MARK	DATE	DESCRIPTIONS	BY	CH'D	CCO#
REVISIONS					
⚠2	01/31/07	CORROSION PROTECTION	JD	AS	16
⚠1	01/21/06	W2 CAP BEAM ISD	JD	NV	23

CONTRACT CHANGE ORDER NO. 16
SHEET 2 OF 12

SAN FRANCISCO OAKLAND BAY BRIDGE
EAST SPAN SEISMIC SAFETY PROJECT
SELF-ANCHORED SUSPENSION BRIDGE
(SUPERSTRUCTURE & TOWER)

W2 CAP BEAM POST-TENSIONING DETAILS NO. 1

TOP TENDON LAYOUT PLAN ("E" Line)
1:50

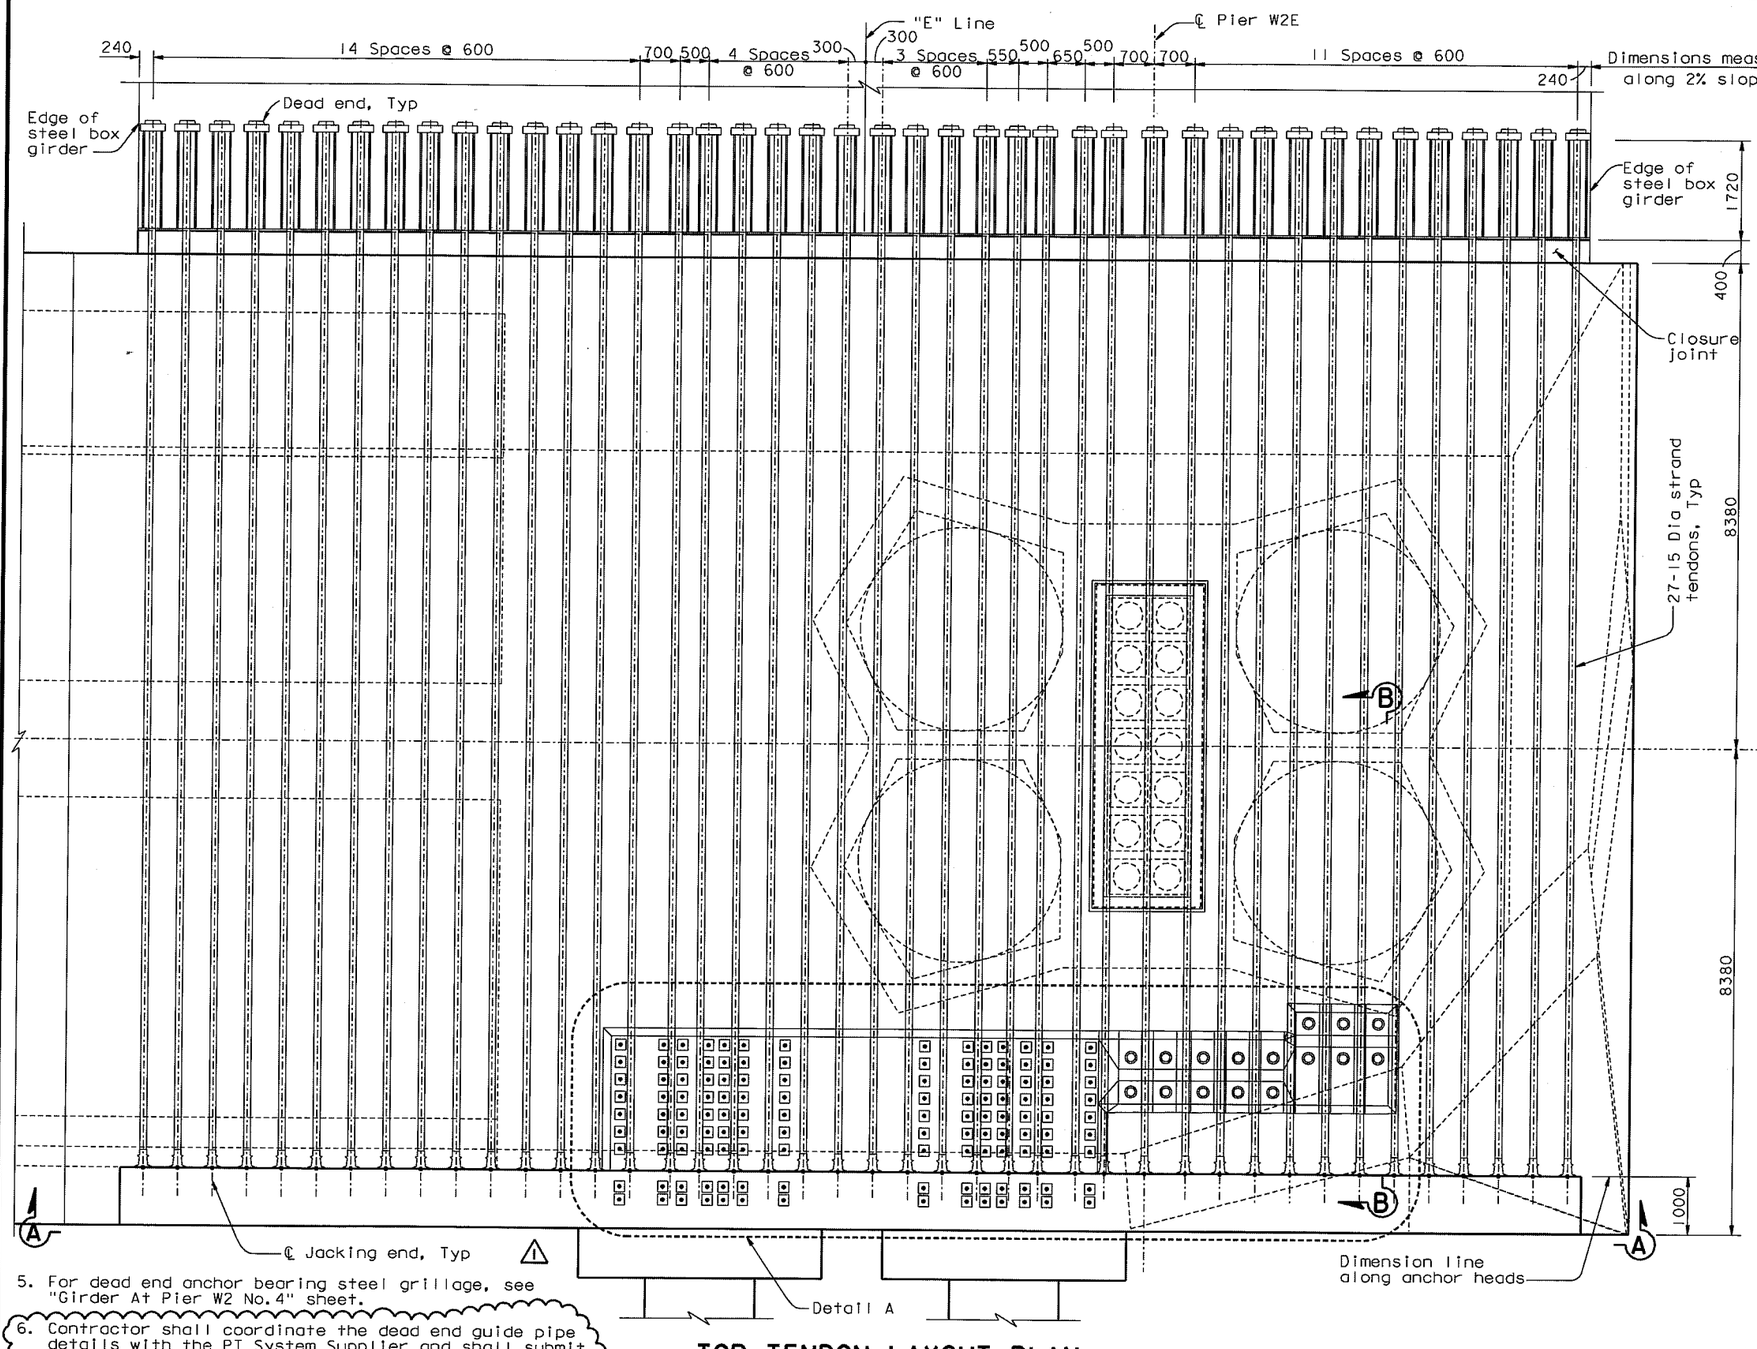
5. For dead end anchor bearing steel grillage, see "Girder At Pier W2 No. 4" sheet.
6. Contractor shall coordinate the dead end guide pipe details with the PT System Supplier and shall submit them to the Engineer for review and approval. Contractor shall grout the guide pipe after stressing operations have been completed. 2

⚠2 **ELEVATION** (Cap beam transverse PT tendons)
1:50

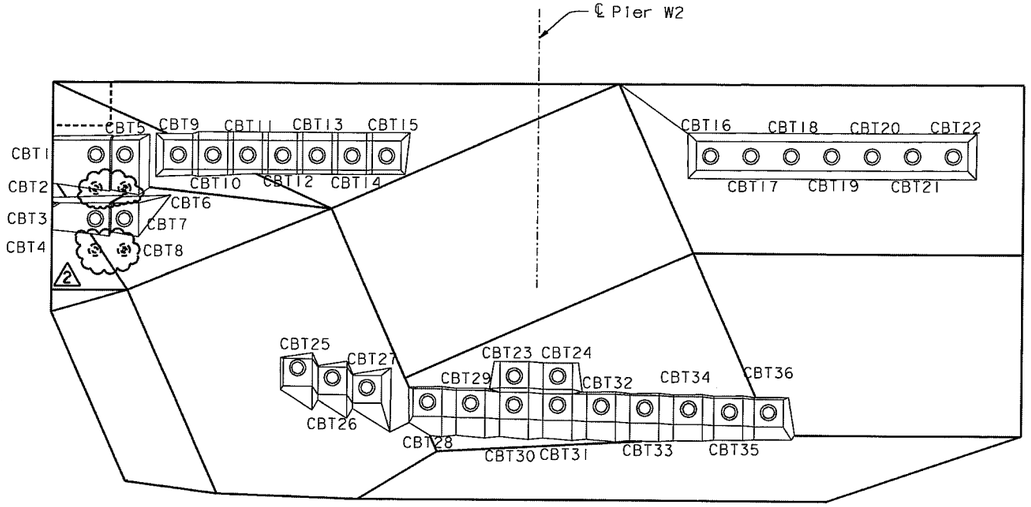
MARK	DATE	DESCRIPTIONS	BY	CH'D	CCO#
		REVISIONS			
⚠2	01/31/07	CORROSION PROTECTION	JD	AS	16
⚠1	07/21/06	W2 CAP BEAM ISD	JD	NV	23

2 DEAD END GUIDE PIPE
NTS (see Note 6)

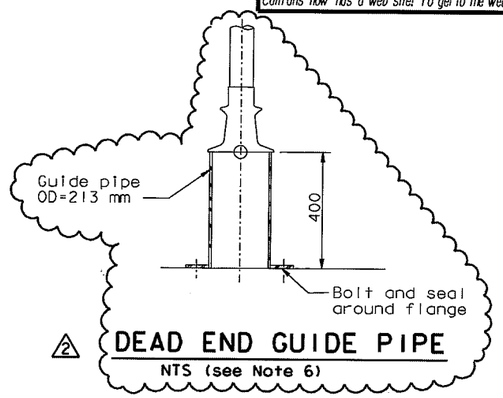
1. Cap beam reinforcement not shown for clarity.
2. Local confining spiral reinforcement for tendon anchors shall be provided by PT tendon hardware supplier.
3. Blockouts on the cap beam "E" Line shown, blockouts on the cap beam "W" Line similar.
4. 1 For Details A and C, see "W2 Cap Beam Blockout Details No. 12" sheet.
5. For additional prestressing details, see "Prestressing Notes" sheet.
6. 2 Contractor shall coordinate the dead end guide pipe details with the PT Supplier and shall submit them to the Engineer for review and approval. Contractor shall grout the guide pipe after stressing operations have been completed.
